Access Compliance Report

Public Rights-of-Way

(Island Curb Cuts)

Intersection ID: 10019482	Main Street: ALEXANDER_RD	Cross Street: N/A	Location:	N/A
ADA ID: 17A1F9BAFE3E	Curb Cut Type: MedianRefuge2	Initial Pass/Fail: Pass	Overall Compliance: No	Severity Score: 0.25
Codes/Mitigation Info/Possible Solution		Field Measurements/Component Compliance

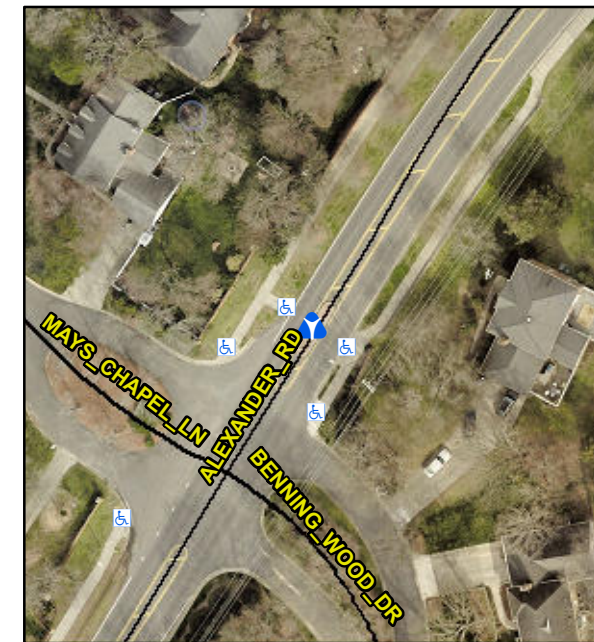
N/A	Road 2 Slope (%)	0.5	Yes	DWS 2 Full Width?	Yes
N/A	Road 2 X Slope (%)	3.9	No	DWS 2 Offset (In)	3.5
N/A	Refuge 3 Length (in)	N/A	N/A	Gutter 3 Ponding?	N/A
N/A	Refuge 3 Width (in)	N/A	N/A	Gutter 3 Lip Ht (in)	N/A
N/A	Refuge 3 Slope (%)	N/A	N/A	Gutter 3 Slope (%)	N/A
N/A	Refuge 3 XSlope (%)	N/A	N/A	Gutter 3 XSlope (%)	N/A
N/A	Painted X Walk3?	N/A	N/A	DWS 3 Provided?	N/A
N/A	X Walk 3 Direction	N/A	N/A	DWS 3 Contrast?	N/A
N/A	X Walk 3 Width (in)	N/A	N/A	DWS 3 Length (in)	N/A
N/A	Road 3 Slope (%)	N/A	N/A	DWS 3 Full Width?	N/A
N/A	Road 3 XSlope (%)	N/A	N/A	DWS 3 Offset (in)	N/A
Yes	Any Obstructions?	No	N/A	Storm Grate/Utility Hazard?	No
N/A	Obstruction Type		N/A	Storm Grate/Utility Type	
		N/A			N/A
N/A	Surface Condition	Good

Remove & Replace Detectable Warning System.
